LUHO-25-009

Land Use Hearing Staff Report

Re: Reconstruction of a Noncomplying Structure

Property Address: 4733 South Mile High Drive

Street view image showing former deck after it was permitted - 2010

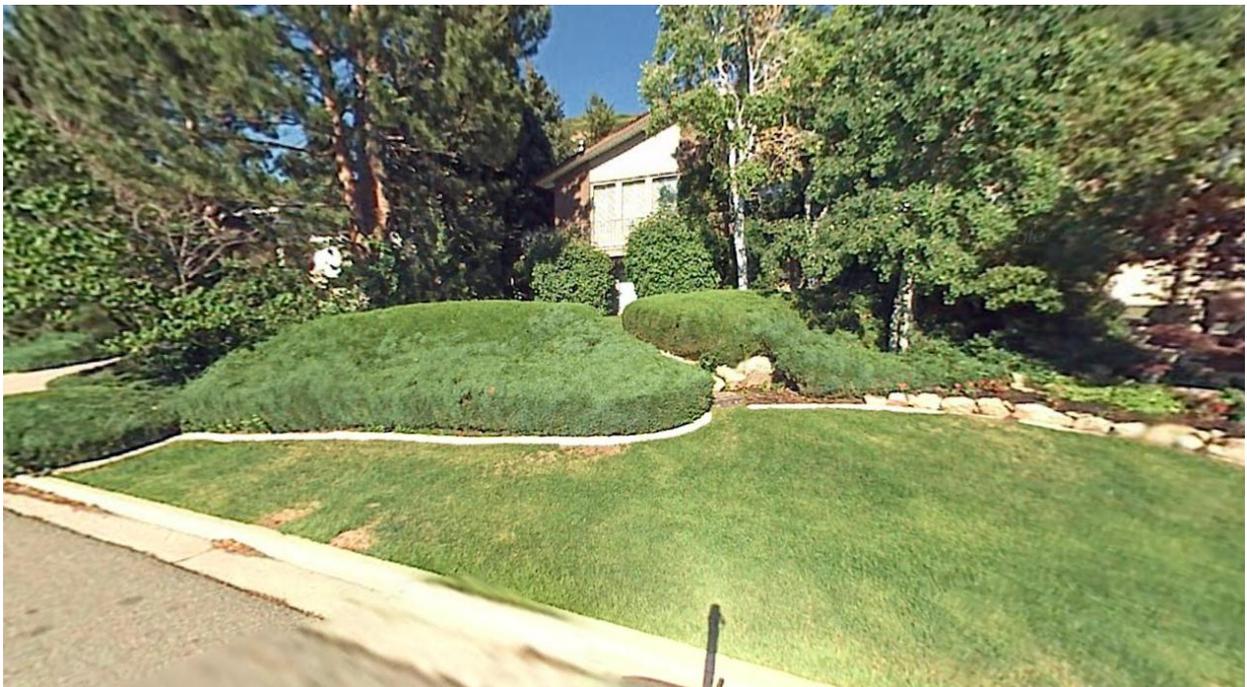
3. Millcreek obtained record of a building permit issued by Salt Lake County on July 15, 2008, for a deck addition on the property. That permit is attached to this report.
In 2010, the front yard set back in an R-1-10 Zone was 30 feet. Staff believes that a permit on this property may have been issued in error, because the deck did not comply with front or side setbacks at the time the permit was approved. However, the land use approval was clearly indicated on the permit, and the site plan did not include any redlines, corrections, or setback information.

Photos from Code Compliance Case

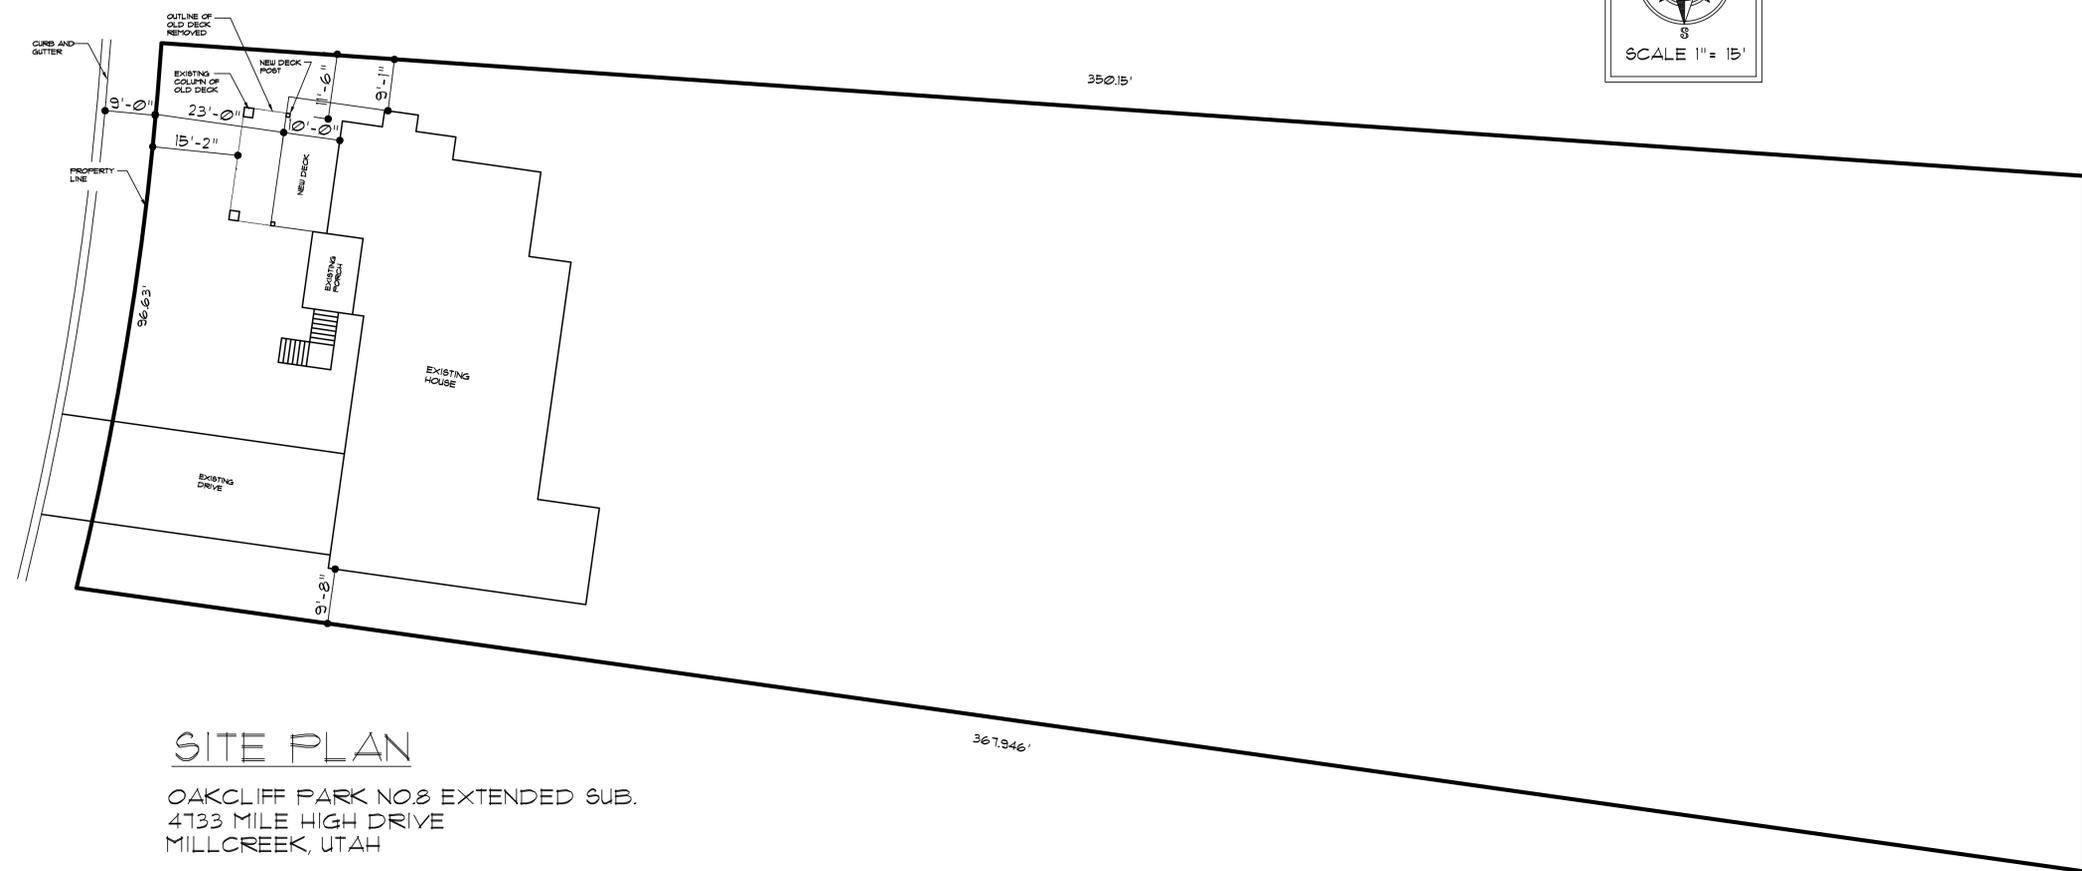
This image shows the replacement deck under construction, without a permit. A stop-work order was issued in January 2025, pending planning approval (and a Land Use Hearing Officer permit). The old deck, since demolished, extended to the top edge of the rockery wall depicted in the photo.

As part of the review of the unpermitted replacement deck, staff is requiring the applicant to avoid encroaching into the side yard setback on the north side of the house. This will require modification of the structure as it was partially built in January.

The revised deck site plan shows that the replacement deck will have a compliant side yard setback.
